UNITED STATES PATENT AND TRADEMARK OFFICE

10/574,836

Office Action Summary	Application No. 10/574,836	Applicant(s) BEHAR ET AL.	
	Examiner JONATHAN WOOD	Art Unit 3754

DETAILED ACTION

Figure 3B of *Lass*, as annotated by examiner

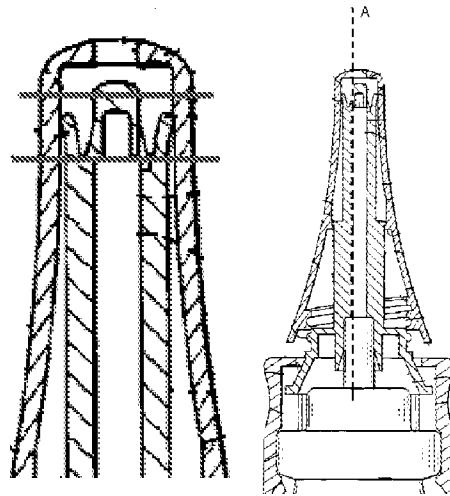
Regarding claim 1, *Lass* shows a fluid dispenser head for mounting on an actuator rod (12) of a pump (§18, ll. 8-9) that is displaceable down and up along an axis (A, Figure 3B of *Lass* below, as annotated by examiner), the head having an axial connection sleeve (22) for engaging on the actuator rod (§ 51, ll. 2-4) and defining an inlet duct (23), a dispenser endpiece (40) defining an endpiece channel (area between top line and top of 40 in Figure 3B below, as annotated by examiner), the endpiece including a dispenser orifice (48) at a downstream end of the endpiece channel, and a bearing surface (top side of 47 to 46) on which axial pressure can be exerted, wherein the endpiece extends substantially parallel to and offset from the axis (extends along axis X in Figure 3B which is laterally offset from axis A), and wherein the bearing surface extends axially downstream from the connection sleeve and intersects the axis (intersects the axis A at the top portion of 47, Figure 3B below, as annotated by examiner), the head further comprising a base skirt (29 to 31 and 32) that extends around the connection sleeve and has an outline in which the endpiece is inscribed

(Figure 3B), the endpiece being actually tangential to the skirt (portion 28 is tangential to portion 29 and portions 47 and 46 are tangential to portion 31).

Regarding claim 4, *Lass* shows the head comprising an inner core (20) and an outer casing (40), the core being axially engaged in the casing (at 27 and 45), the core forming the connection sleeve and part of a connection channel (area between lines in Figure 3B above, as annotated by examiner), the casing forming the dispenser endpiece and a bearing wall (46 to 47) defining the bearing surface.

Regarding claim 8, *Lass* shows the core forms an axial spout (21 to 35) that is engaged in the endpiece (Figure 3B), a bottom portion of the endpiece channel being formed between the casing and the spout (Figure 3B above, as annotated by examiner).

Regarding claim 10, *Lass* shows the spout includes an end (35) that terminates in a position set back from the dispenser orifice (Figure 3B), a top portion of the endpiece channel being formed solely by the casing downstream from the spout,

(Figure 3B above, as annotated by examiner), the dispenser orifice being formed in the top portion (Figure 3B).

Regarding claim 11, *Lass* shows the core forms a bearing plate (34) into which the duct opens out axially (Figure 3B), the connection channel being formed between the plate and the casing (Figure 3B above, as annotated by examiner).

Regarding claim 16, *Lass* shows the bearing surface slopes (Figure 3B) and forms an angle of 90° relative to the axis (at top horizontal sections of 46 and 47), in such a manner as to intersect the axis (Figure 3B above, as annotated by examiner).

Regarding claim 18, *Lass* shows a dispenser comprising a pump (§18, ll. 8-9) having an actuator rod (12) that is displaceable down and up along an axis (A, Figure 3B of *Lass* above, as annotated by examiner) and a dispenser head (10) comprising an axial connection sleeve (22) that connects to the actuator rod (§ 51, ll. 2-4) and defines an inlet duct (23), an endpiece (40) comprising an endpiece channel (area between bottom line and top of 40 in Figure 3B above, as annotated by examiner) connected to the inlet duct (Figure 3B above, as annotated by examiner), the endpiece including a dispenser orifice (48) at a downstream end of the channel, wherein the endpiece extends substantially parallel to and offset from the axis (extends along axis X in Figure 3B which is offset from axis A), and a bearing surface (top side of 47 to 46) on which

axial pressure can be exerted, wherein the bearing surface intersects the axis (intersects the axis A at the top portion of 47, Figure 3B below, as annotated by examiner), the head further comprising an inner core (20) and an outer casing (40), the core being axially engaged in the casing (at 27 and 45), the core forming the connection sleeve and part of the channel (Figure 3B above, as annotated by examiner), the casing forming the dispenser endpiece and a bearing wall (46 to 47) defining the bearing surface.

Regarding claims 21 and 22, *Lass* shows the inlet duct extends completely through the core (Figure 3B) along the axis (Figure 3B above, as annotated by examiner).

Regarding claim 24, *Lass* shows the dispenser head having a bearing surface (top side of 47 to 46) on which axial pressure can be exerted, wherein the bearing surface intersects the axis (intersects the axis A at the top portion of 47, Figure 3B below, as annotated by examiner).

13. Applicant's arguments with respect to the 35 USC 102(b) rejection of claim 18 over *Lass* have been fully considered but they are not persuasive. Applicant first argues that *Lass* does not disclose "a pump having an actuator rod displaceable along an axis". However, examiner refers applicant to ¶18, lines 8 and 9 of *Lass* which disclose the device of *Lass* being used on a pump instead of a valve. Applicant then argues that elements 46 and 47 can not be considered as a bearing surface. However, given the teachings of *Lass* to use the dispenser head on a vertically actuated valve or pump, examiner argues that 46 and 47 do in fact represent bearing surfaces on which a user can press downwardly as well as laterally. Applicant further argues that neither element 46 or 47 intersects the axis. However, given examiner's definition of axis A in Figure 3B above, it can be seen that the axis does in fact intersect wall 47 (see Figure 3B above, as annotated by examiner). Finally, applicant argues that the endpiece of *Lass* is axial, and not offset away from the axis. However, given examiner's definition of axis A in Figure 3B above, the endpiece's axis (X) is indeed laterally offset from A.
